From: ALAN ALLISON [REDACTED]
Sent: 02 December 2019 18:58
To: Andrew Wood <Andrew.Wood@arun.gov.uk>
Subject: email to Parish Council 25 November Minor Amendments Lanes End WA/7/19/RES

Comments on Option Unit 6

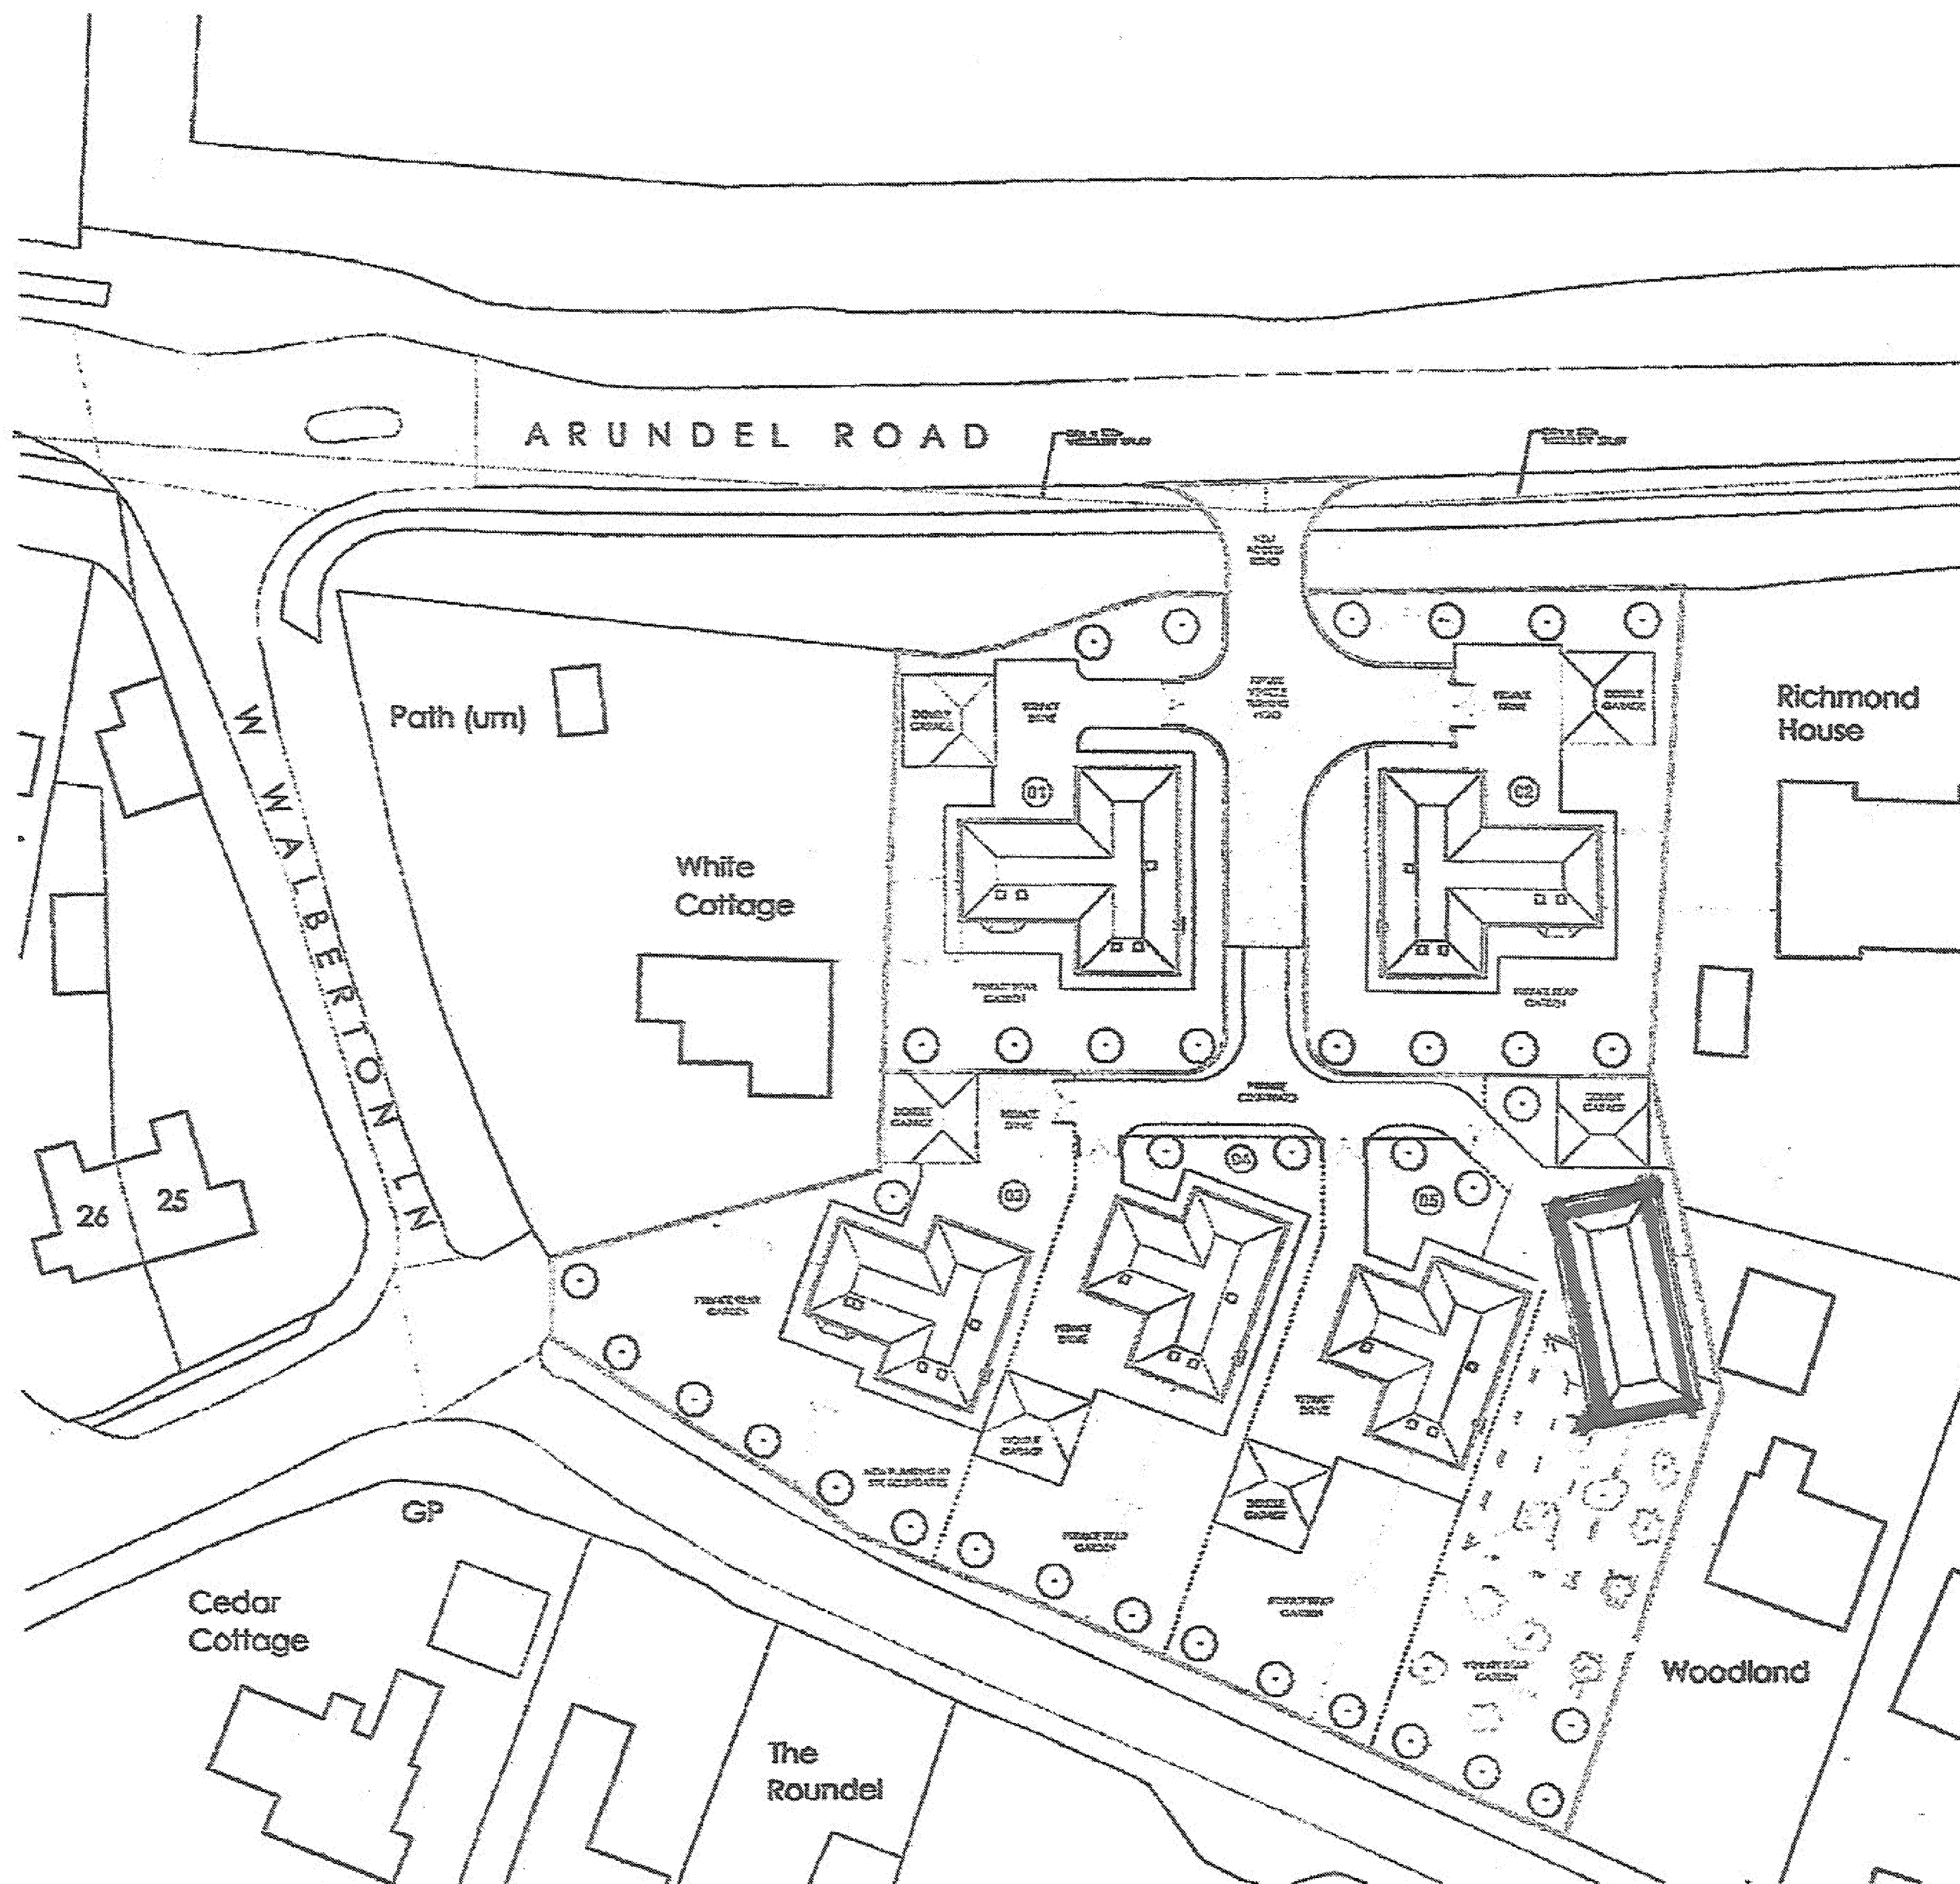
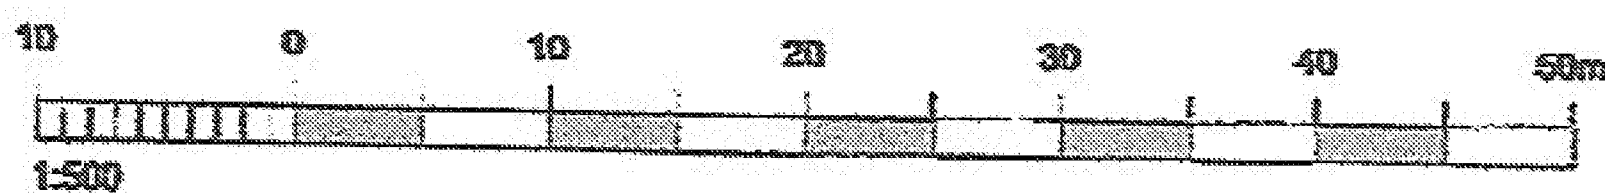
1. The view from Woodland would be badly affected. The existing Lanes End house is c40 metres from the boundary, but the unit 6 is less than 5 metres.
2. The size and closeness of unit 6 would mean a major loss of natural light in Woodland, our house, and would cast a large shadow over Woodland, its patio, conservatory and gardens on sunny afternoons
3. Most unit 6 windows will probably be on the wall facing Woodland, and more than on previous plans. These windows should be obscured glass and non-opening, to protect privacy of Woodland occupants.
4. Surface water run-off from the building will have an immediate effect on Woodland property.

1. The moving of unit 6 south from the outline plan position to the now proposed position shortens the garden length, and will badly affect its use as there are 2 trees with TPOs at the southern end of the plot.

2 Being so close to Woodland house would mean a major loss of privacy in unit 6.

It would be better for everyone to move unit 6 further North and turned slightly as shown on attached drawing A&V dated 1.12.2019 – nearer the position in the approved outline Block Plan. This removes most overlooking and privacy loss in both directions.
